Question 1

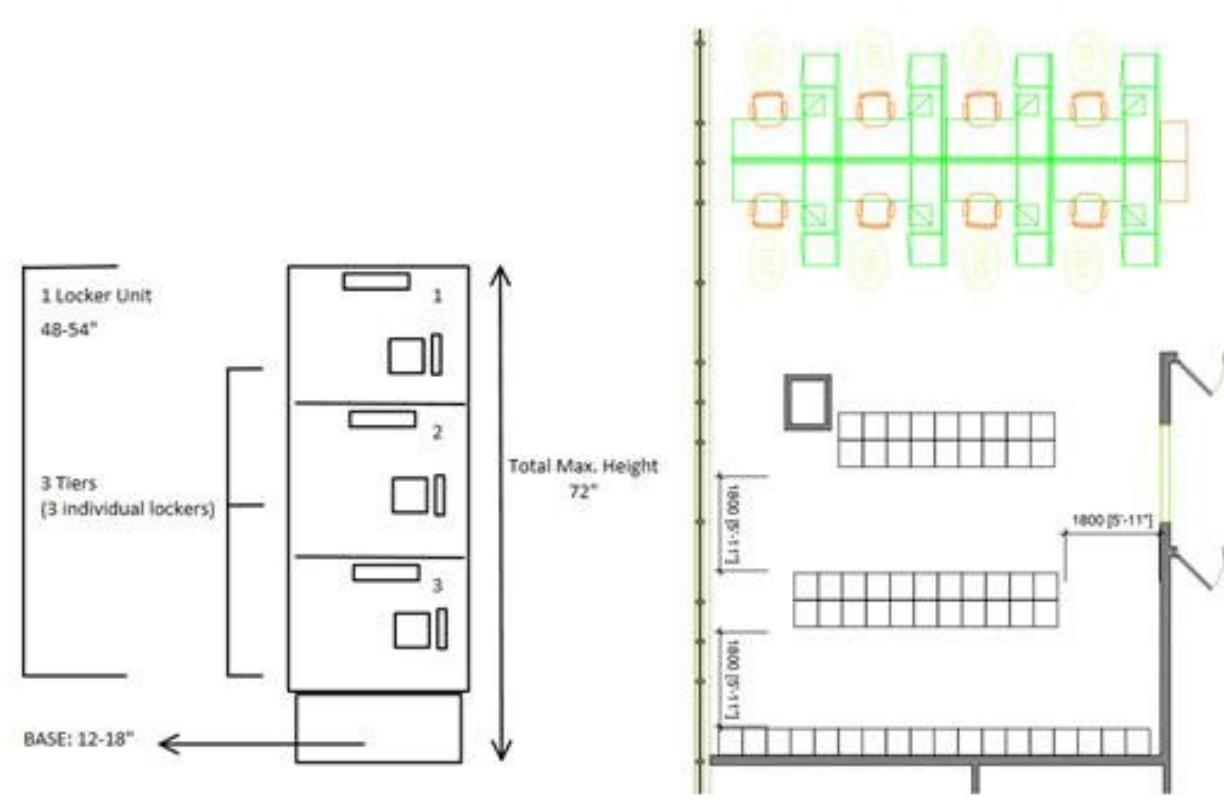
Q: Are we able to provide dual lockers to make up the correct quantity as opposed to single.

Sommes-nous en mesure de fournir des casiers double au lieu de casiers simple pour constituer la quantité requise?

A: Each locker unit must include three tiers (three individual lockers per unit). The units can come in any configuration (single, double, triple) as long as the required layout can be maintained (attached) and a total of 58 units (174 individual lockers) is achieved.

Chaque unité de casiers doit inclure trois niveaux (trois casiers individuels dans chaque unité). Les unités peuvent avoir n'importe quelle configuration (simple, double, triple) tant que la disposition (ci-joint) peut être maintenue et un total de 58 unités (174 casiers individuels) est atteint.
